**BLYTHER SOLAR POWER PROJECT (09-AFC-6)**  
**CEC STAFF DATA REQUESTS 30 – 50**

**Technical Area: Alternatives (AFC Section 4.0)**

**Response Date: January 6, 2010**

**Figure DR-ALT-35-1  
Transmission Line Alternatives with Parcel Map**

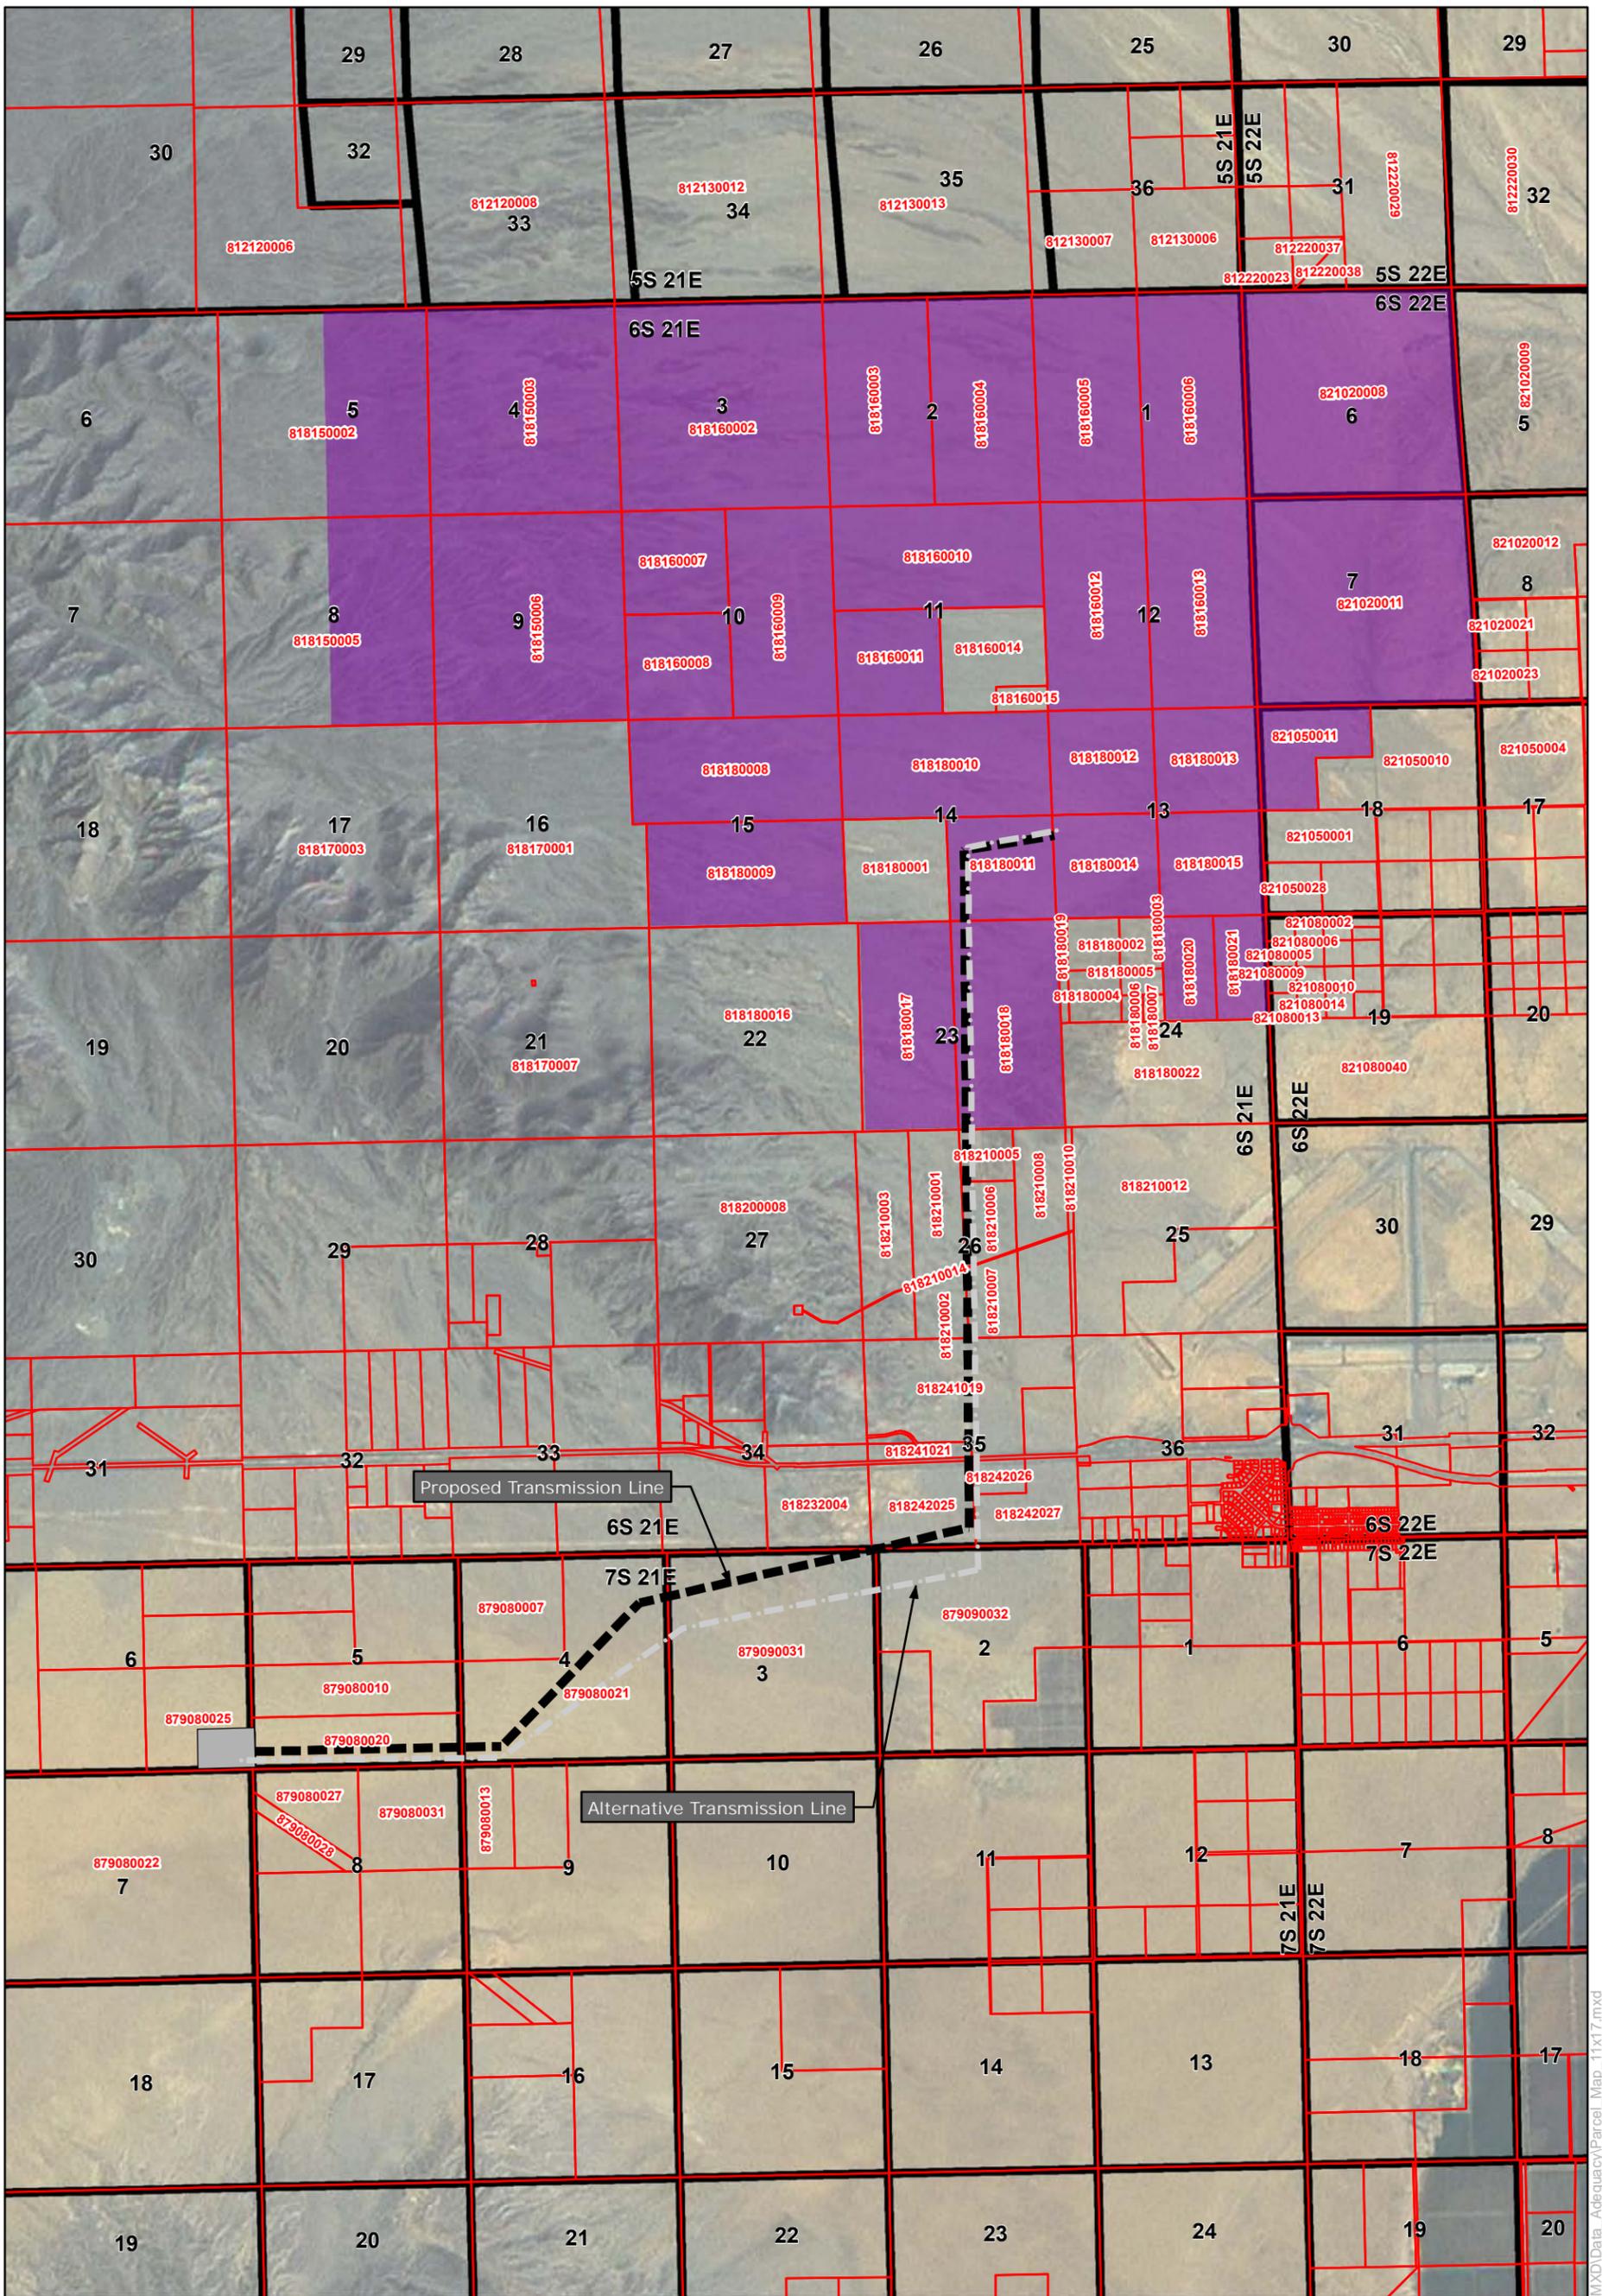
Given the uncertainty regarding the transmission line route and possible substation location, please detail what additional transmission line routes or substations are being considered. Illustrate all options on a detailed map that includes section numbers and boundaries.

Figure DR-ALT-35-1 shows the transmission routes and substation alternatives that have been considered. There are two routes being considered. However, either of the two routes would terminate at the same planned SCE Colorado River substation where the BSPP would interconnect with the SCE system. Thus, both transmission routes terminate at the location that has been selected by SCE for the substation facility.

One of the two transmission line routes was the one included in the July 2009 AFC and the other route is included in the October 2009 AFC Volume 3 Data Adequacy Supplement.

**Figure DR-ALT-36 -1**  
**CNDDDB Search Results**  
**for Alternative Site:**  
**East of Lancaster**

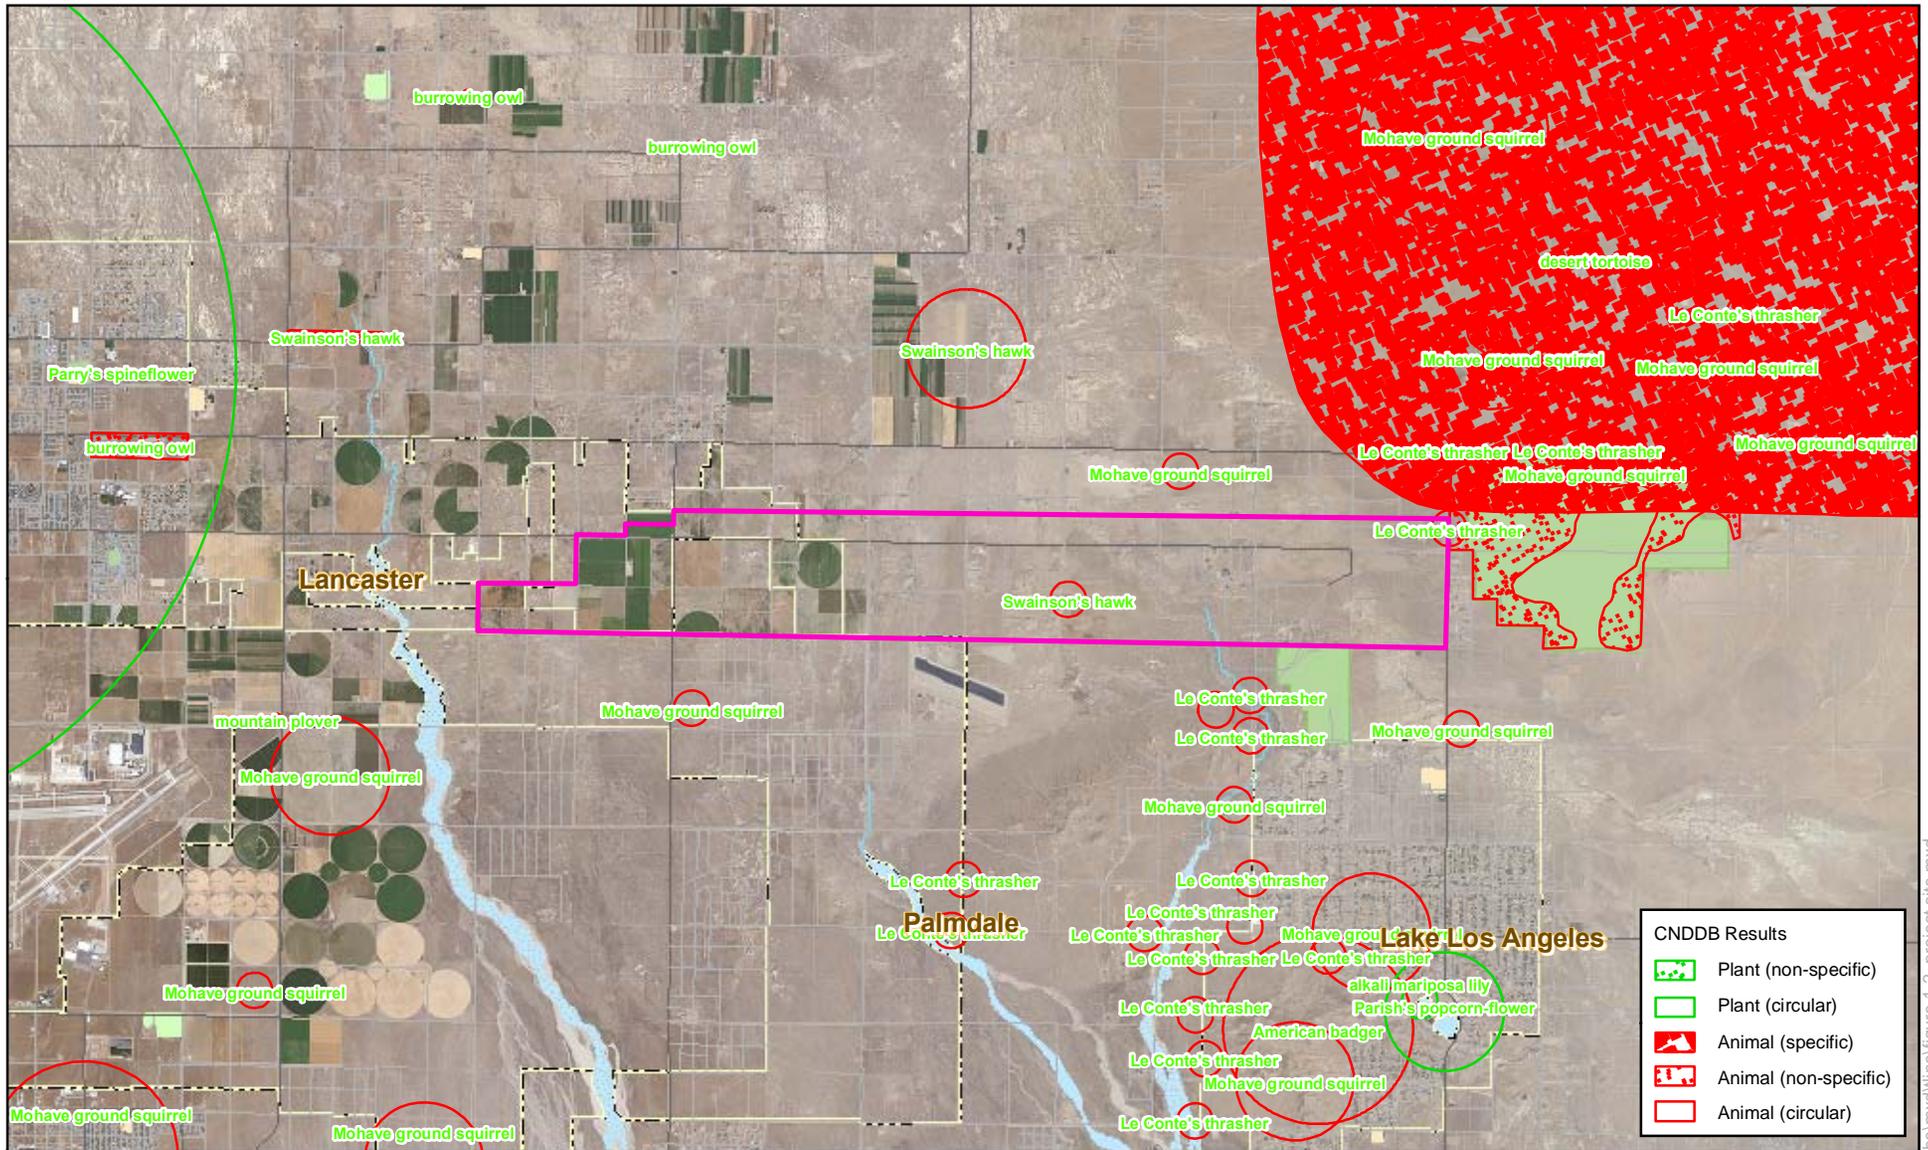
One of the site selection criteria for the proposed Blythe SPP site was environmental sensitivity. Please provide the results of a CNDDDB search for the East of Lancaster alternative site.

Figure DR-ALT-36-1 illustrates the results of the CNDDDB search conducted for the East of Lancaster site. The species identified at the site and within a 5-mile radius are listed immediately below:

**Blythe Solar Power Project**  
**Figure DR-ALT-38 -1**  
**CNDDDB Search Results**  
**for Alternative Site:**  
**Blythe Disturbed Land**

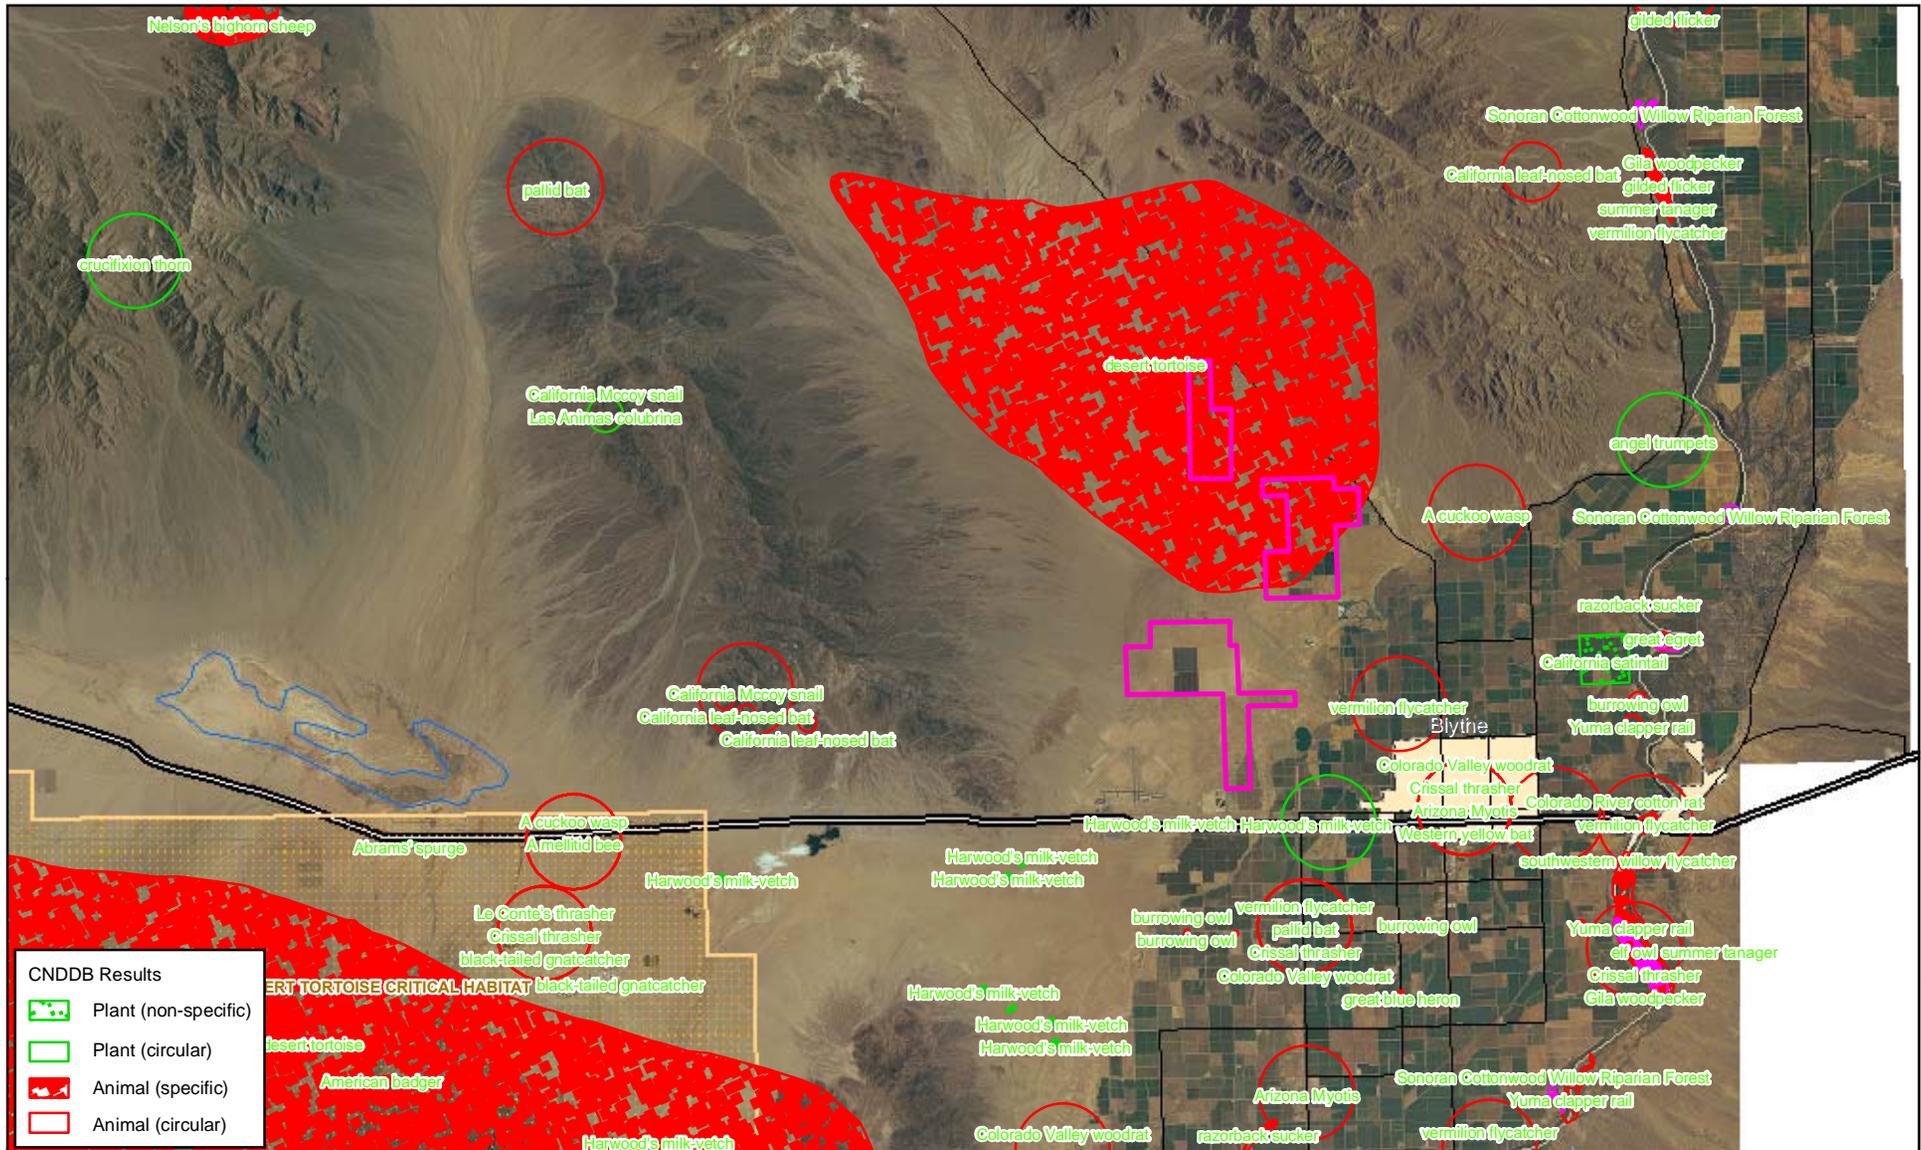
Please provide the results of a CNDDDB search for the Blythe Disturbed Land alternative site.

Figure DR-ALT-38-1 shows the results of the CNDDDB search for the Blythe Disturbed Land alternative site. The data shown is for the site plus a 5-mile radius. The species identified in the search are listed immediately below:

**Figure DR-ALT-42-1  
Earlier Project Configuration  
Including Private Land**

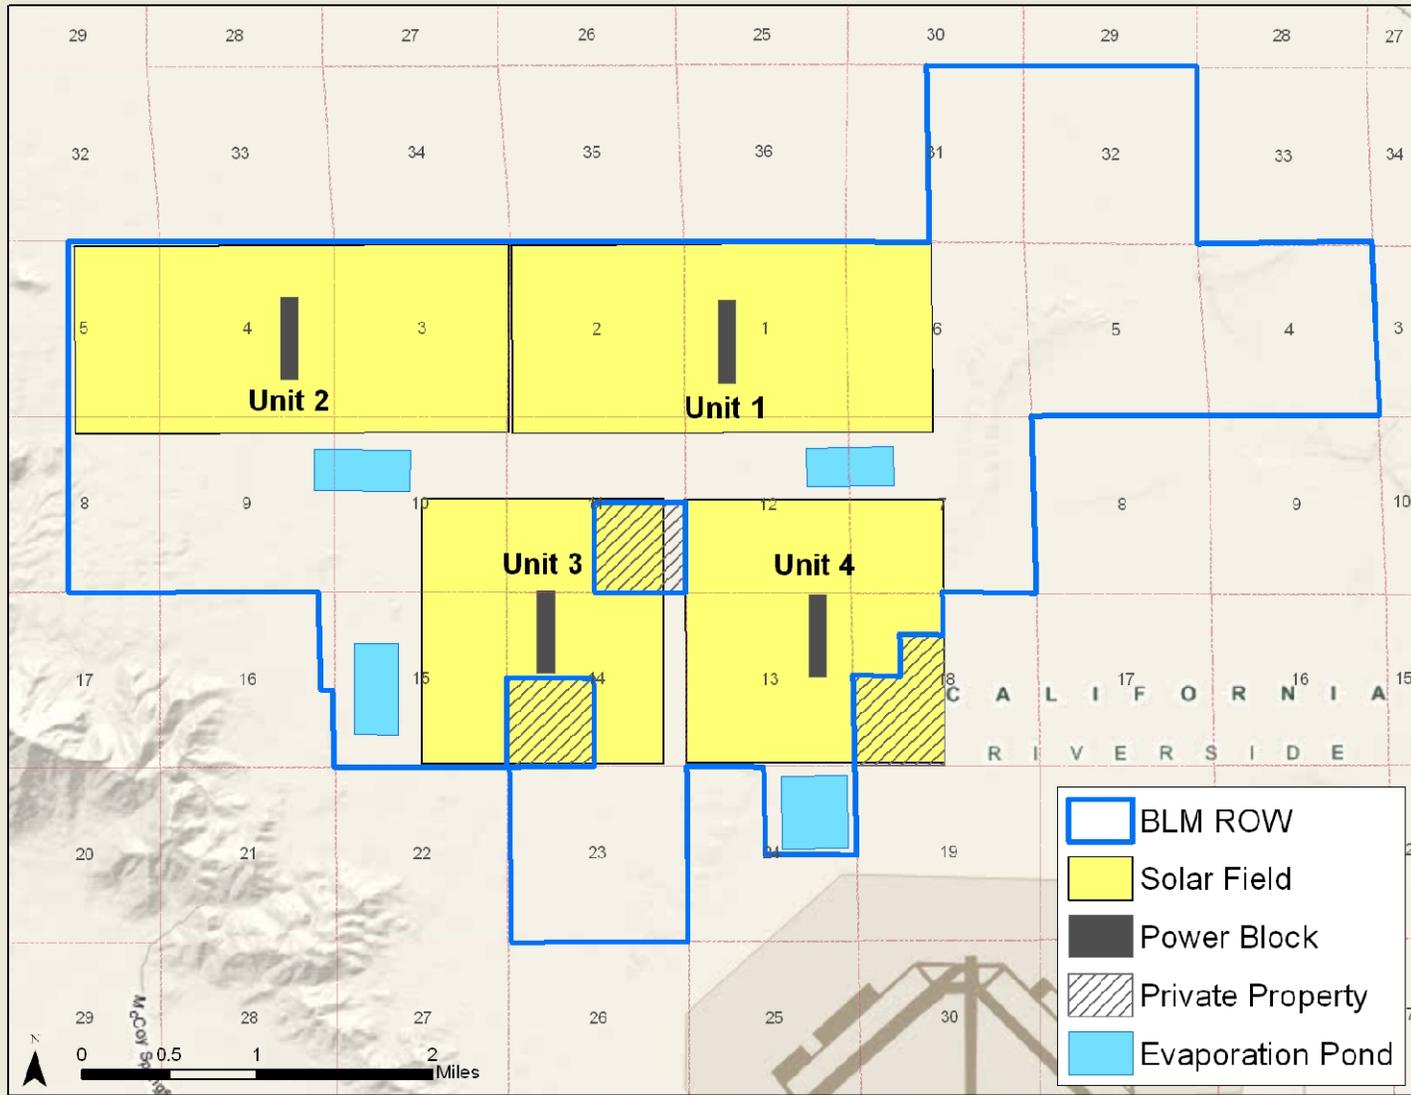
Please provide detailed information regarding any alternative configurations/engineering considered but rejected by the applicant. Please include details regarding the engineering constraints to each alternative configuration.

In an earlier configuration of the Project, the solar fields were designed to utilize three of the private parcels in and around the Project ROW (see Figure DR-ALT-42-1). Due to difficulties in acquiring the private parcels, the Applicant created a layout used in the BLM ROW application that included only BLM land (see Figure DR-ALT-42-2). In addition, in June 2009, the Applicant decreased the ROW size for BSPP by relinquishing three and a half sections in the northeast portion of the ROW. In earlier site layouts, the northeast area was planned for solar energy generation. This area, partly in the McCoy Wash, was relinquished for environmental stewardship reasons to minimize the Project’s impact on biological and cultural resources (see Figure DR-ALT-42-3).
